9 January 2018

**Request for advice  
Stage 1 State Significant development application  
for over station development at Martin Place (SSD 8351)**

**Figure 1 – Comparison of proposed envelope and envelope with podium setbacks**

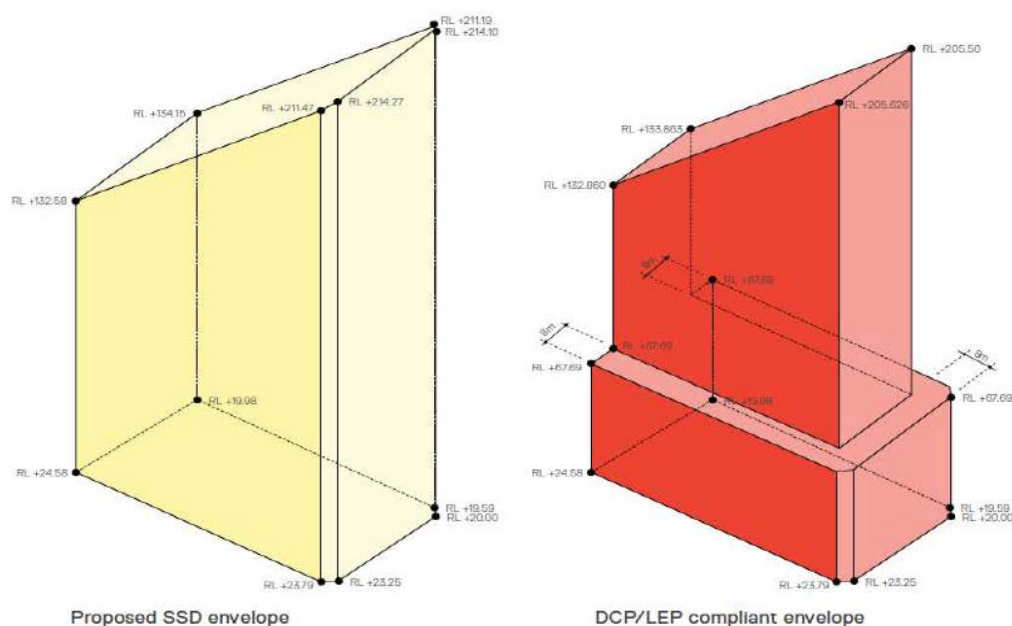
While the applicant argued that the height and envelope controls in the *Sydney Local Environmental Plan 2012* "did not anticipate or plan for additional floor space capacity released by recent investments in public transport infrastructure", on balance, the Commission agrees with the City's arguments. The existing street wall and the prescribed setbacks above the street wall height in Castlereagh and Elizabeth Streets is an established, identifiable characteristic of the locality that supports public amenity and aligns with the heritage fabric of the area, including that established by 50 Martin Place. The podium/tower envelope objectives set out by the City in its various development controls, as indicated in the comparative envelopes for the north building in **figure 1** below, are a well-reasoned urban design response to these local contextual features.

The Commission considers that the applicant's proposed envelopes, particularly for the north building, could result in very large, bulky development. The indicative design scheme shows a massive north building attached to and tapering above 50 Martin Place with little relief and limited opportunities for mid-block pedestrian permeability at ground level. The Commission considers that such an approach would have a significant negative impact on the urban outcome and be distinctly out of character with the surrounding buildings and their context.

The Commission acknowledges the Department's view that very careful design resolution will be required at stage 2. However, the Commission considers that the street walls for both north and south sites, the boundary setback from 50 Martin Place at podium level of the northern tower and the southern tower setback to Martin Place are worthy of strong reinforcement by way of physical setbacks, and that these should be incorporated into the concept approval for the building envelopes. In this respect, the City's suggestion of 'at least' a four-metre setback above the podium appears to the Commission to be a suitable compromise between the eight metres that would otherwise be specified by the City, and the transformative urban and commercial opportunities presented by the site.

On this 6,500-square metre site, the inclusion of a podium setback would not be prohibitive to large campus-style floor plates. Indeed, many of the lower and mid-level floor plates of the tower shown in the indicative scheme are already significantly above 2,000 square metres. The Commission recognises the applicant's contention that other new tower buildings in the vicinity in Hunter Street do not have setbacks from the street. Nonetheless, for pedestrian amenity, it is the Commission's view that tower to ground typology for the Hunter Street elevation could be appropriate if it can be demonstrated that wind conditions will be improved as a result.

1. The proposed building envelopes should be modified by way of a boundary setback at podium height of at least four metres along Elizabeth and Castlereagh Streets (for both the north and south towers) and a setback from 50 Martin Place at podium height of at least four metres to the southern boundary of the north tower;
2. The maximum envelope above the podium for the southern tower be setback 25 metres from the northern site boundary of Martin Place;
3. A tower to ground typology for the Hunter Street elevation could be appropriate only if it can be demonstrated that wind conditions will be improved as a result. Simply maintaining the current unsatisfactory conditions is not considered acceptable.
